Port Wallace

Committee Comments

SUBJECT: Port Wallace Master Plan – Wilcot Lane

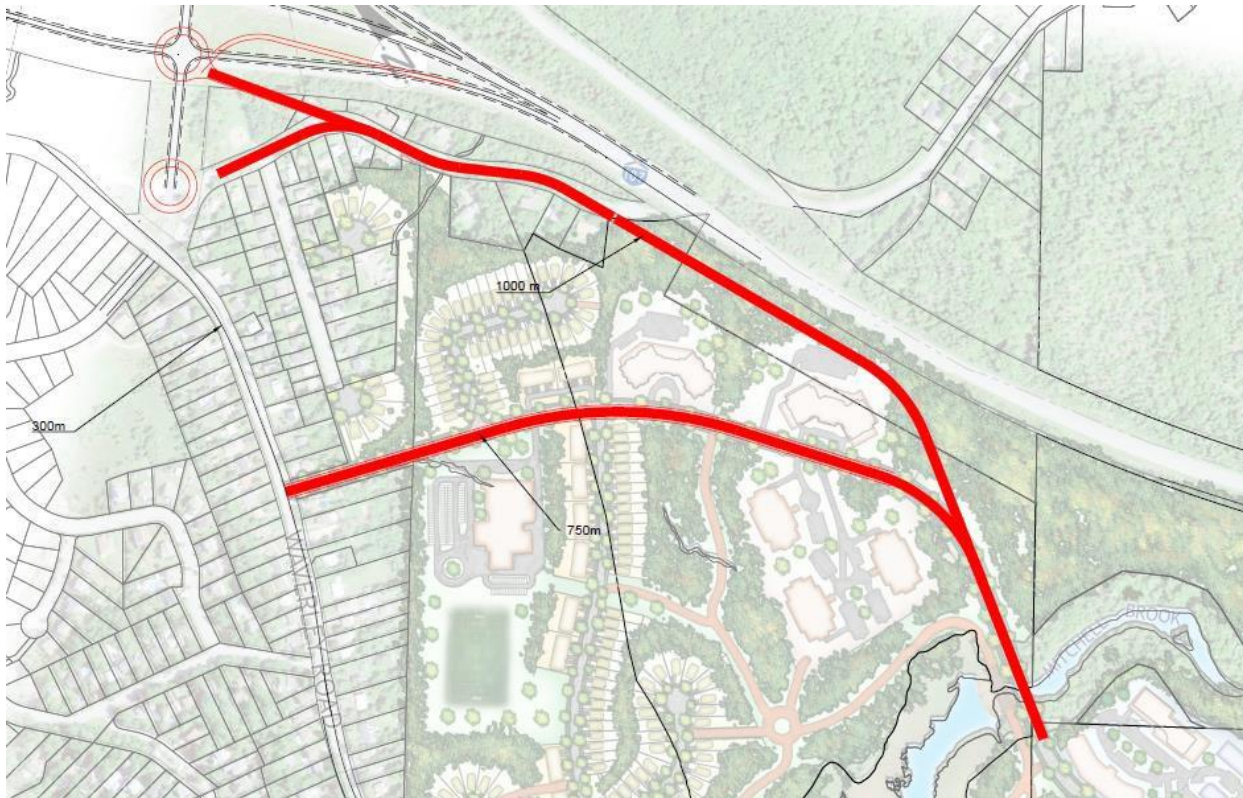
I have shown three alignments in the figure below. Two of the alignments use Wilcot Lane to connect either to a roundabout at the interchange terminal, or a roundabout at the intersection of Waverley Road at Montague Road. The third alignment shows my interpretation of the current proposal.

If Wilcot Road was used, the resulting alignment would be 250 metres longer than the current proposal and would only by-pass 300 metres of Waverley Road. This section of Waverley Road has 24 single family homes as opposed to 16 family homes on Wilcot Lane

A preliminary analysis of the Montague Interchange indicates that it would be expensive to construct a roundabout at the southbound ramp terminals. A roundabout at the Waverley/Montague is also complicated because of the need to provide driveway access to adjacent homes. The infrastructure plan will likely recommend traffic signals at these two locations.

The Wilcot Lane alignments would require acquisition of right-of-way to accommodate the collector road cross section and AT infrastructure.

It is for the reasons described above that I recommend that Wilcot Lane not be considered part of the internal collector road for the Port Wallace development. Let me know if you require anything further.
